**PLANNED UNIT DEVELOPMENT  
STAFF REPORT****Date: December 4, 2003**

**DEVELOPMENT NAME**      Fairfield Place Subdivision

**CONTEMPLATED USE**      Allow 47% site coverage and a 20-foot front yard setback in a R-1, Single-Family Residential subdivision

## SITE PLAN

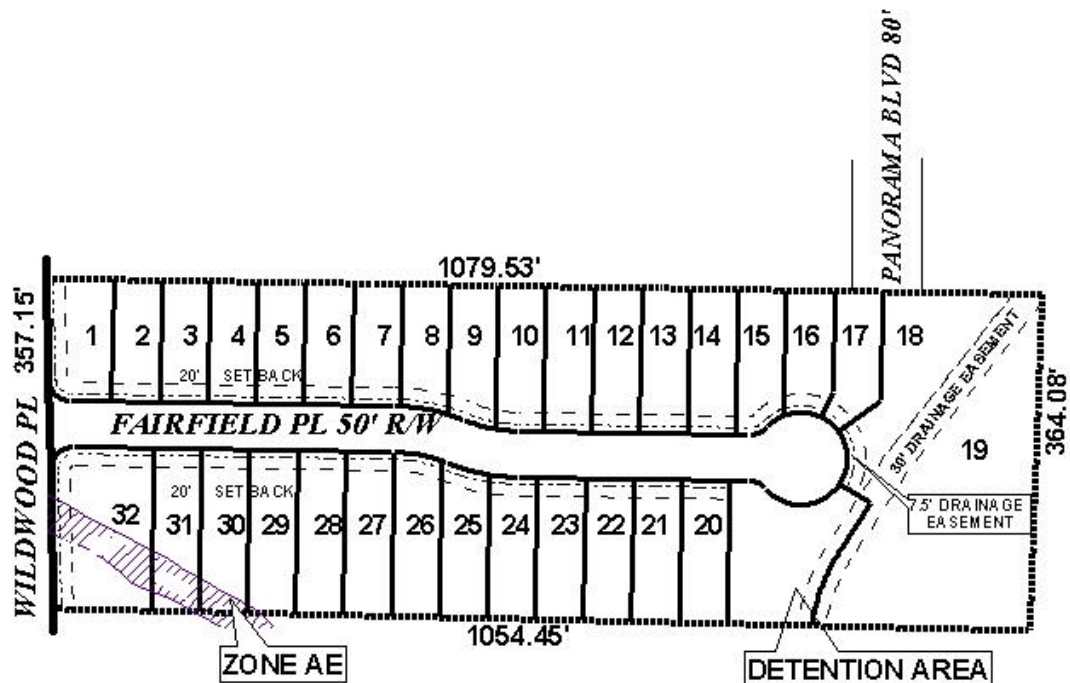
**ENGINEERING COMMENTS**      Developer must confirm stormwater system, including detention system can accommodate increased coverage. Must comply with all stormwater and flood control ordinances. Any work performed in the right of way will require a right of way permit.

In regard to the reduced front yard setback, the site consists of a single cul de sac, and the 20-foot front yard setback would not impact the existing residences that are located outside the development. Additionally, many R-1 Planned Unit Developments have 15-foot front yard setbacks, and thus the request would be consistent with prior PUD approvals granted by the Commission.

The applicant also proposes an increase in site coverage—47 percent. The Commission has consistently approved requests for 45-percent site coverage, and with full compliance with the City Engineering Comments, a slight increase in coverage should not negatively impact properties within or outside the PUD site.

**RECOMMENDATION** This applications is recommended for approval subject to the following condition: 1) full compliance with the Engineering Comments (Developer must confirm stormwater system, including detention system can accommodate increased coverage; must comply with all stormwater and flood control ordinances; and any work performed in the right of way will require a right of way permit).
